May 9, 2017

FRESNO CHAFFEE ZOO WARTHOG EXHIBIT**ADDENDUM NO. 1**

FRESNO CHAFFEE ZOO WARTHOG EXHIBIT**ADDENDUM NO. 1 CONTINUED**

L14.1

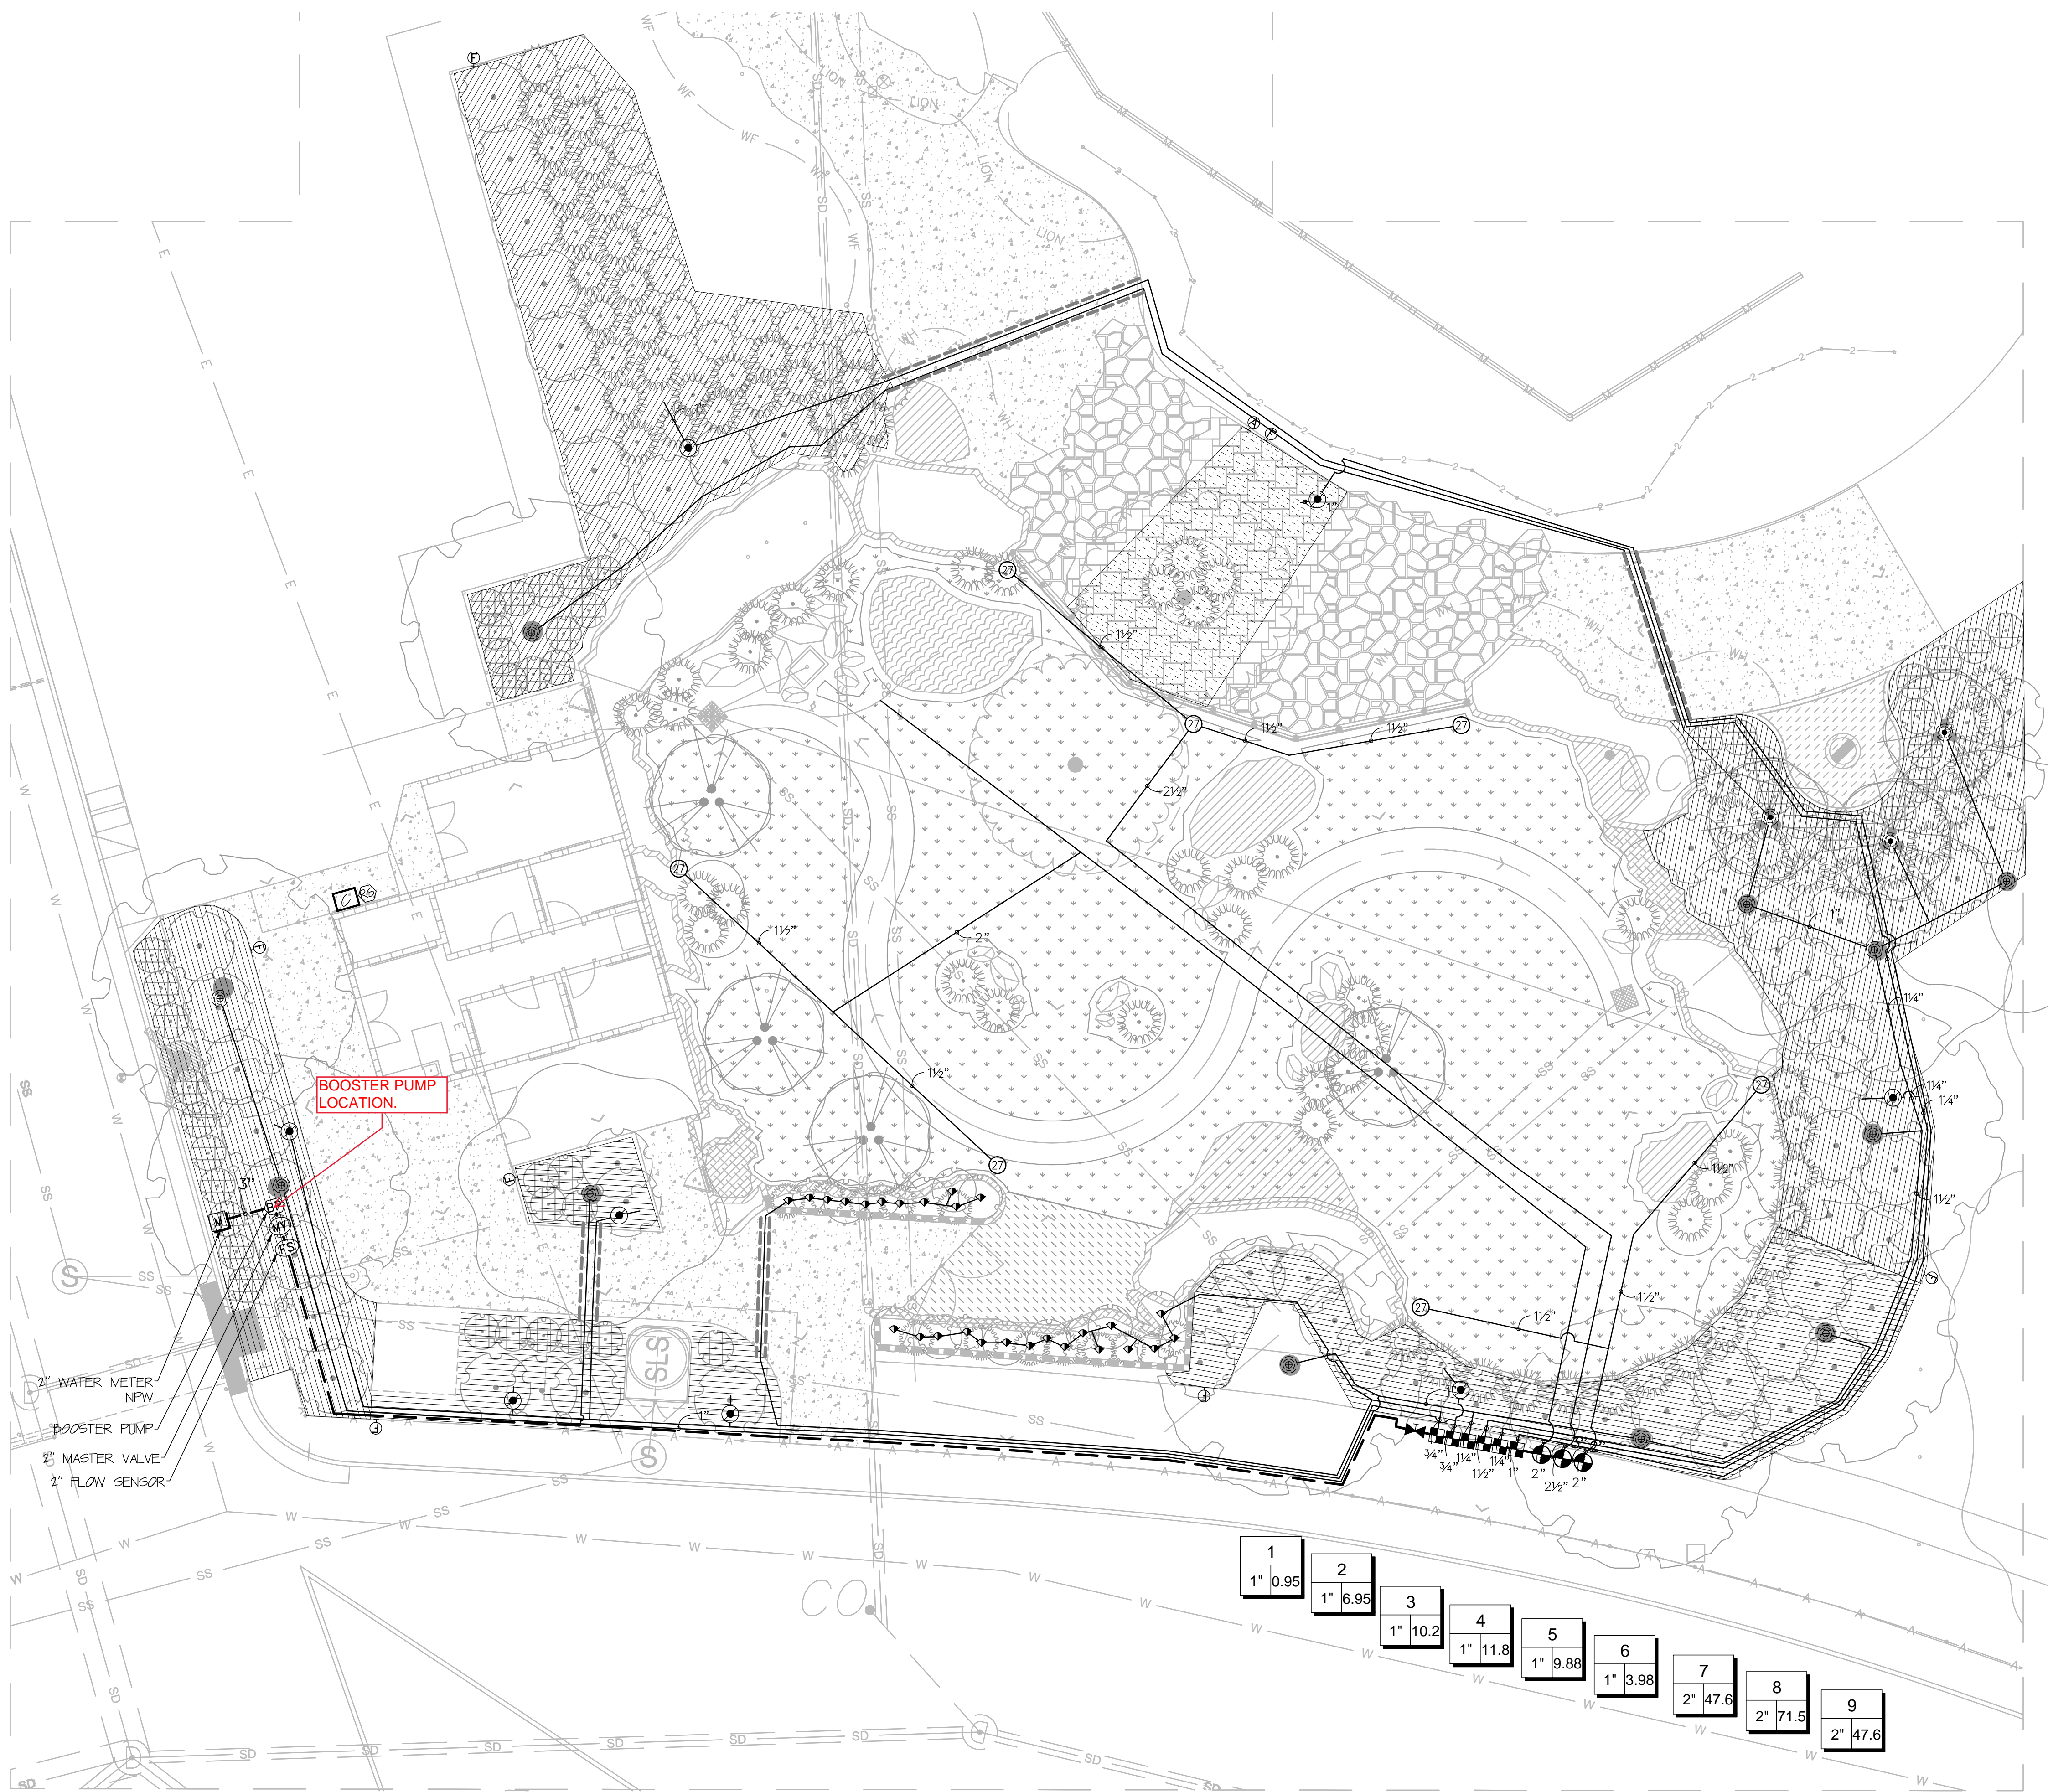
5. **REPLACE SHEET E2 WITH ATTACHED REVISED SHEET E2. PANEL SCHEDULE HAS BEEN REVISED TO INCLUDE BOOSTER PUMP.**
6. **REPLACE SHEET L14.1 WITH ATTACHED REVISED SHEET L14.1 . IRRIGATION SCHEDULE HAS BEEN REVISED TO SHOW BOOSTER PUMP.**

sheet no.
L15.1

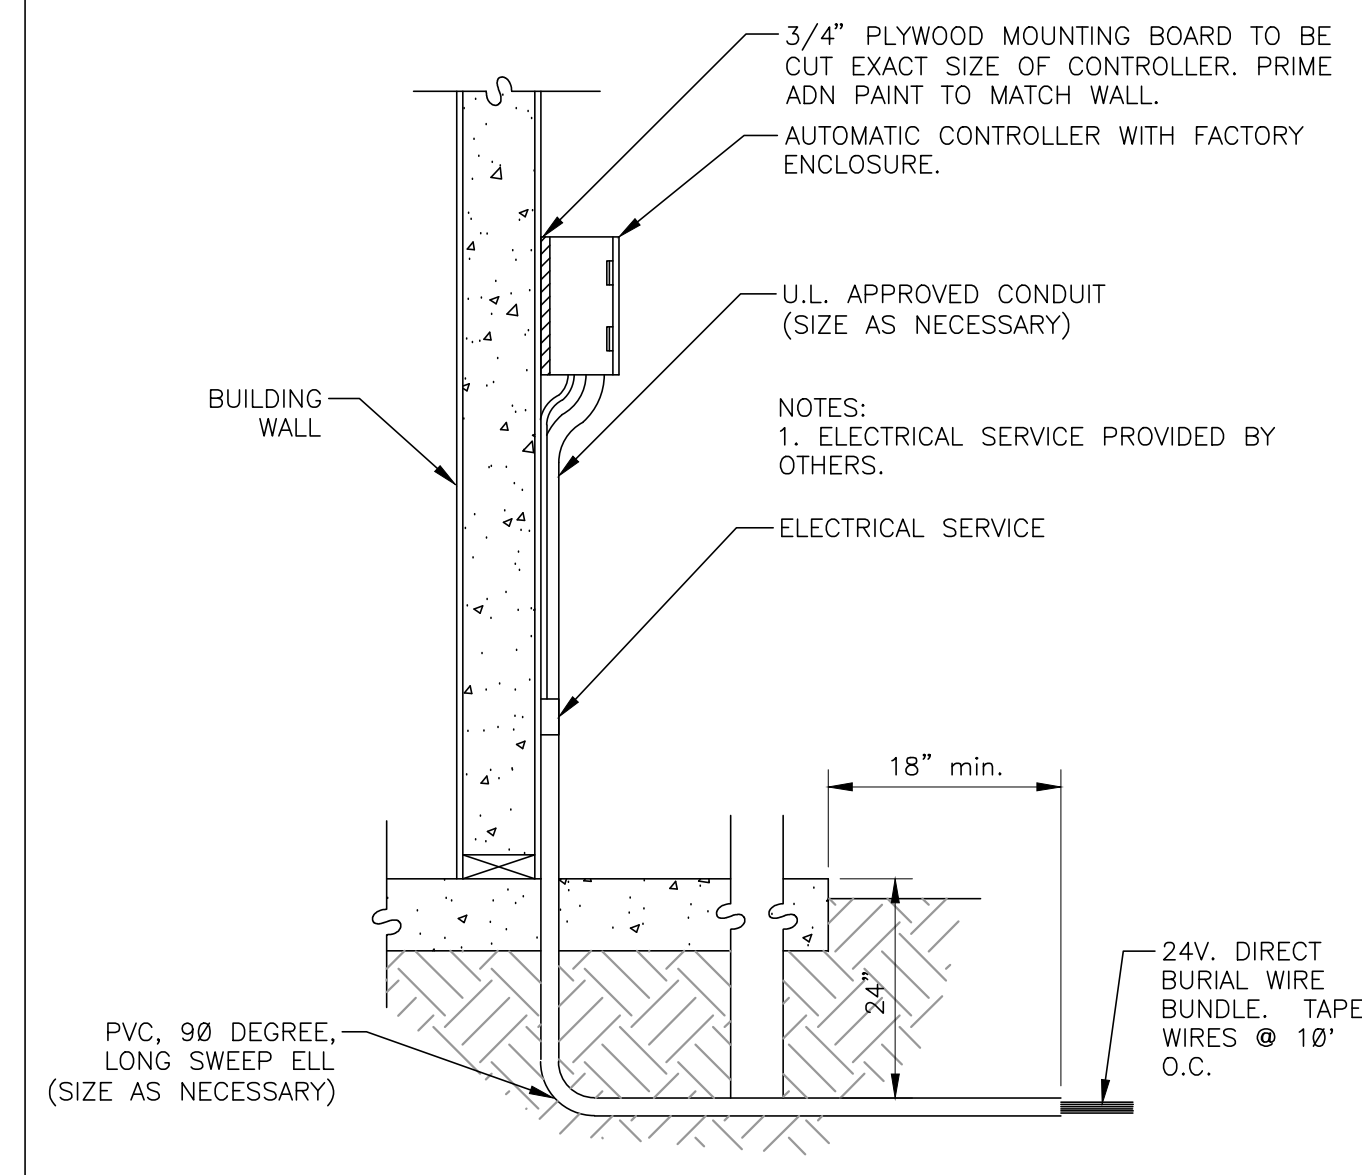
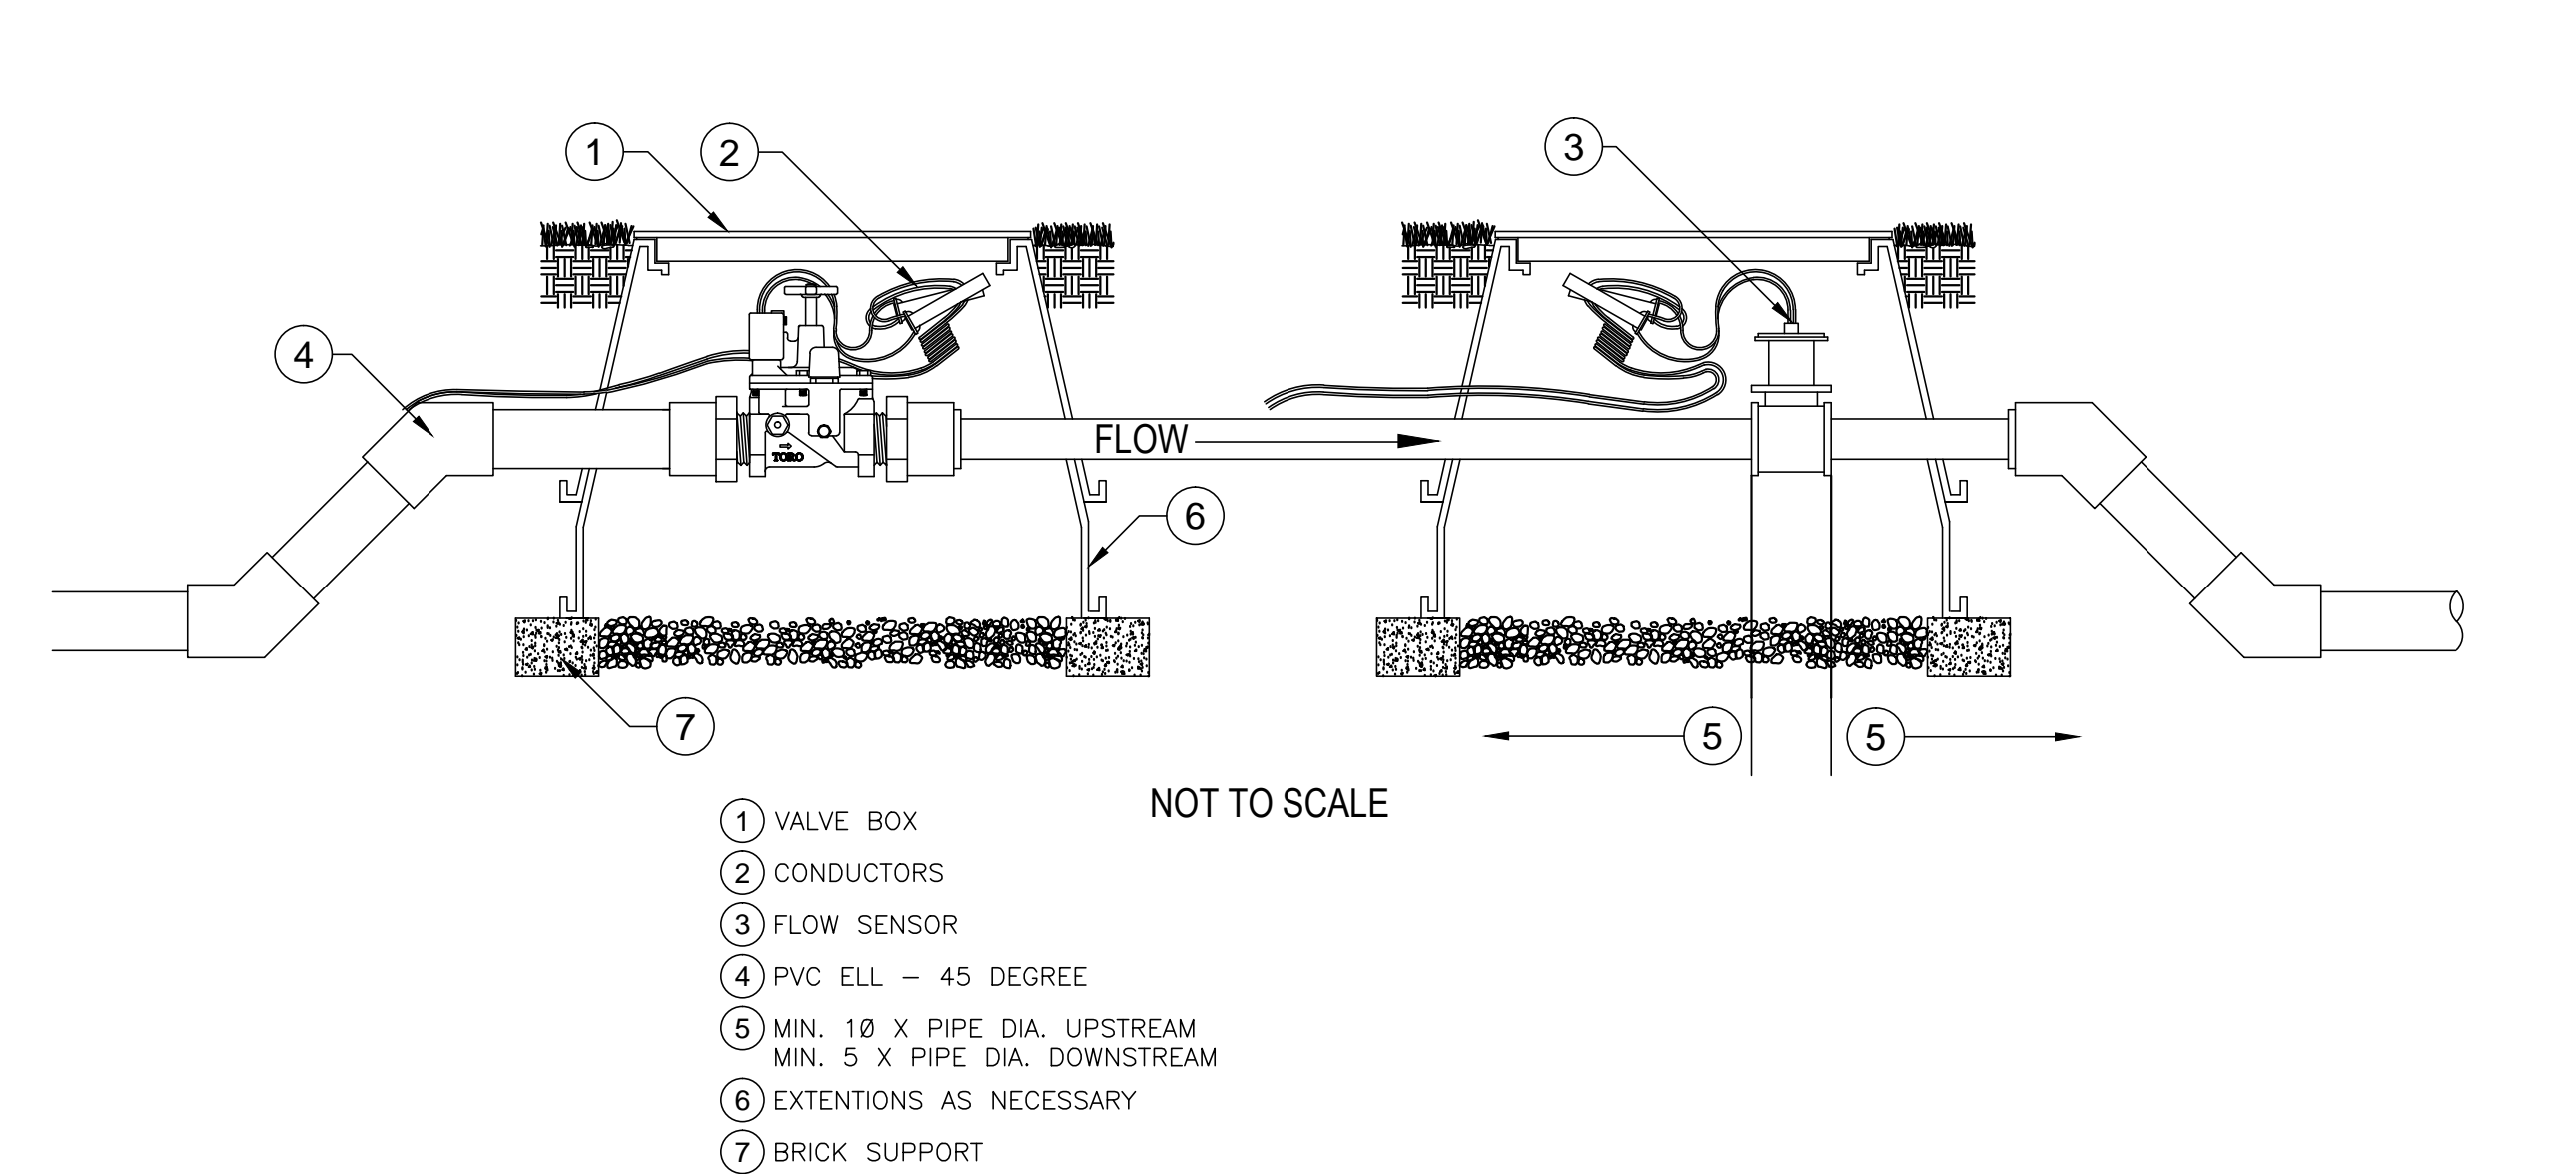
7. **REPLACE SHEET L15.1 WITH ATTACHED REVISED SHEET L15.1 . SITE IRRIGATION PLAN HAS BEEN REVISED TO SHOW BOOSTER PUMP LOCATION.**
8. **REPLACE SHEET L16.1 WITH ATTACHED REVISED SHEET L16.1 . SITE IRRIGATION DETAILS HAS BEEN REVISED TO SHOW BOOSTER PUMP.**
